AIR CONDITIONING - ELECTRIC HEATER THERMAL FUSE REPLACEMENT

MTL-21-02  
Page 1 of 4

Figure 1. Thermal Fuse Installation (Sheet 1)

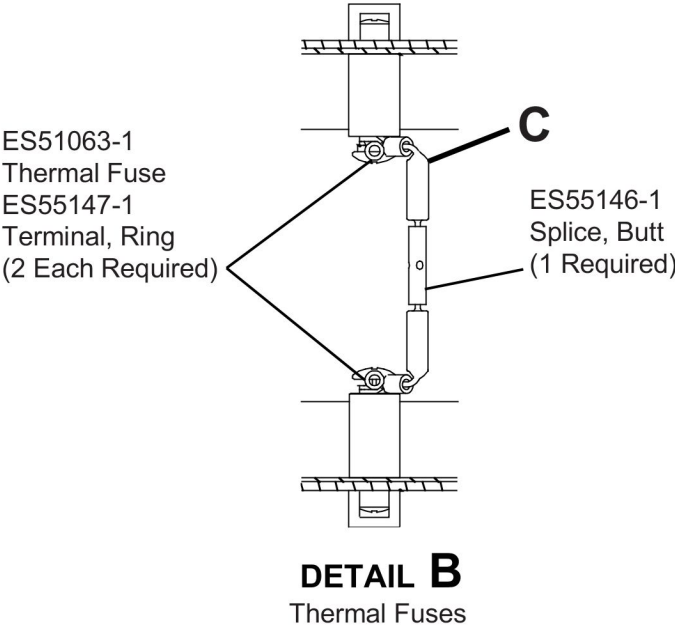
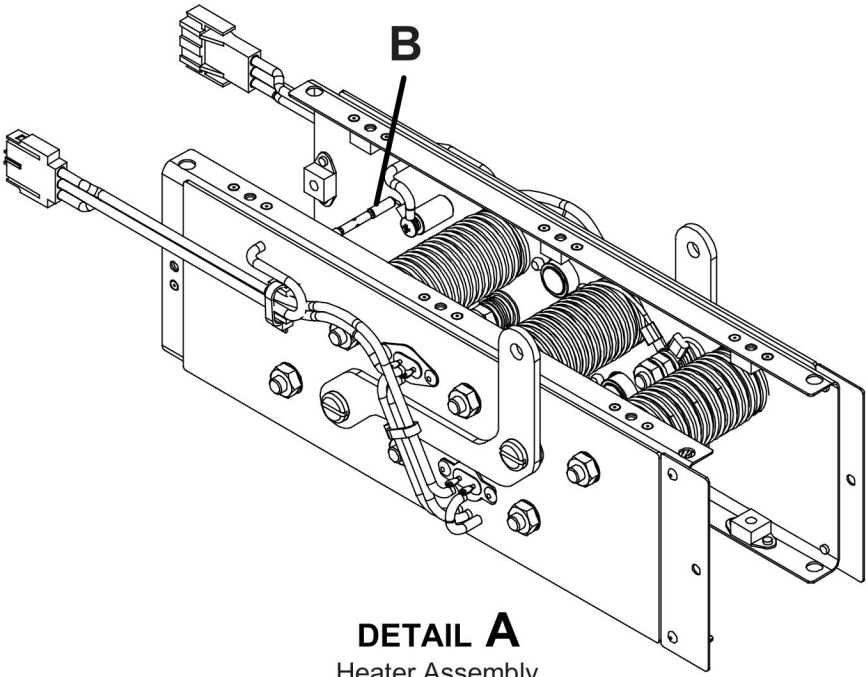
Incorrect value of the thermal fuse installed in the heater assembly. The fuses that were installed will open at a lower temperature than designed and the heater will stop working even though working within the designed temperature range.

This service document provides parts and instructions to replace the thermal fuses in the heater assembly.

**NOTE:** Rotate Thermal Fuses 45-Degree away from heater coils.
